Regarding using block error ratio as performance metric

Related Comments: 394, 395,396, 401,404,411

Guangcan Mi, Erge Li
Huawei

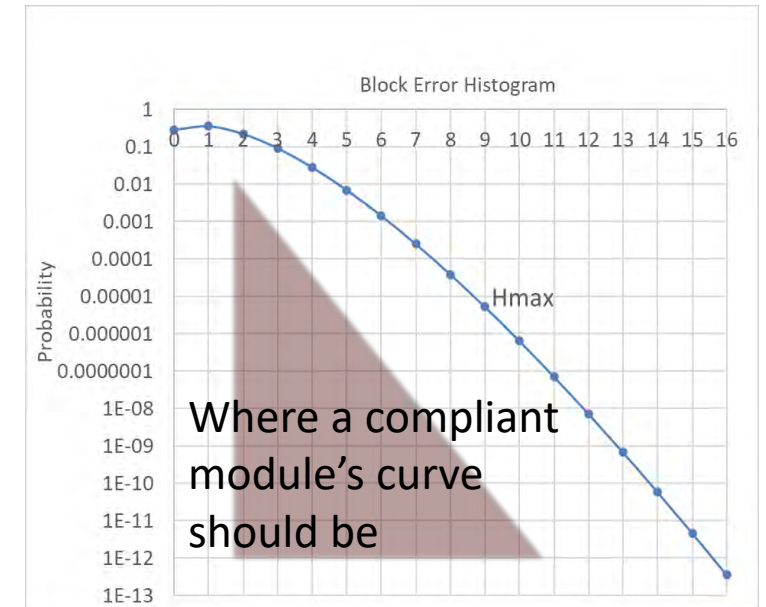
Time consumption = cost of production

Blocks per second: $200\text{G bit} / 5440 / 4 \rightarrow$ **Time to hit 1 count:** $1 / (H_{\max}(i) * 200\text{Gbit} / 5440 / 4)$

Time required for	0.2min	2.6min	31mins	6.4hours	>1day
Bin x to hit 1 count	12	13	14	15	16p

- For real devices, much longer time will be required to get readable bin count. To reach bin 15, it would be e.g. ~1day.
- To have good confidence of the reading, the error count in each bin is expected to be >10. So another factor of x10 of required time
- It is therefore, impractical to **measure** the **full** Histogram,
- So it will be necessary to make statistical projection
 - What we have been doing with BER, i.e. using a result of finite time to predict/represent the behaviour. The issue of BER is actually the threshold being overly optimistic. Reducing the BER to a tighter spec serves as the sorting spec of Rx. Sens.
